ALERT SERVICE BULLETIN

Service Bulletin No.: DA20-79-04A, Rev. 1

Title: Defective Oil Filter

Figure 1

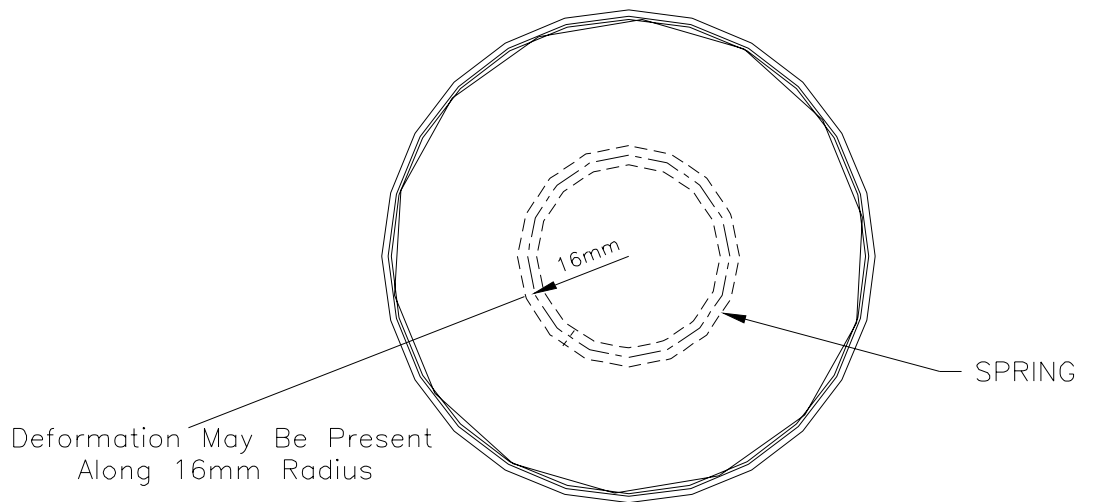
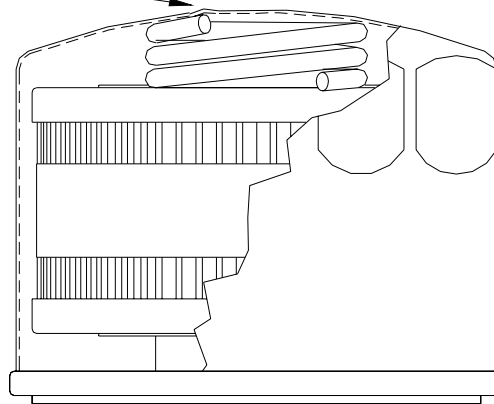
Only a slight defect may be visible
Inspect carefully along the 16mm radius

—VIEW—
Top Of Filter

<u>Item</u>	<u>Qty</u>	<u>Part Number</u>	<u>Description</u>
1	1	825-701	Oil Filter
8. **Special Tools:** Not Applicable.
9. **References:** Doc #DA201 Maintenance Manual.
10. **Accomplishment Instructions:**
 - 10.1 Remove the upper and lower cowling.
 - 10.2 Clean the filter casing.
 - 10.3 Using a light carefully inspect the surface area shown in figure 1.
 - 10.4 If the defect described in figure 1 is present on the outer casing replace the oil filter.
 - 10.5 Replace the oil filter every 50 hours thereafter until the new type oil filter is installed on the aircraft.
